Highgate CAAC objection to [HGY/2023/0252](#) for 13 Shepherds Hill, N6 5QJ

Highgate CAAC objects to this application because the drawings supplied with the application are inadequate.

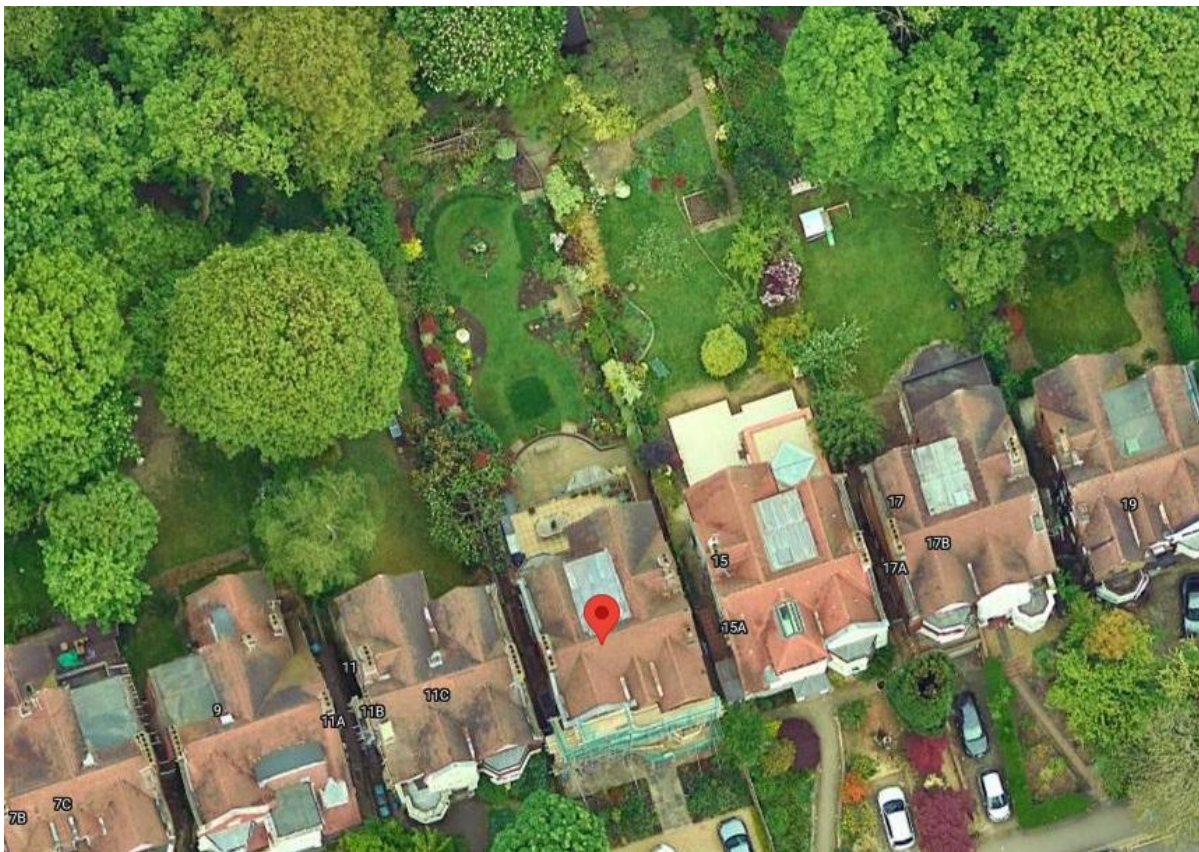
It is not clear that all the drawings are accurate compared to the way the house appears on Google satellite view. For instance it is difficult to see the spiral staircase included in all the drawings of the rear of the house:
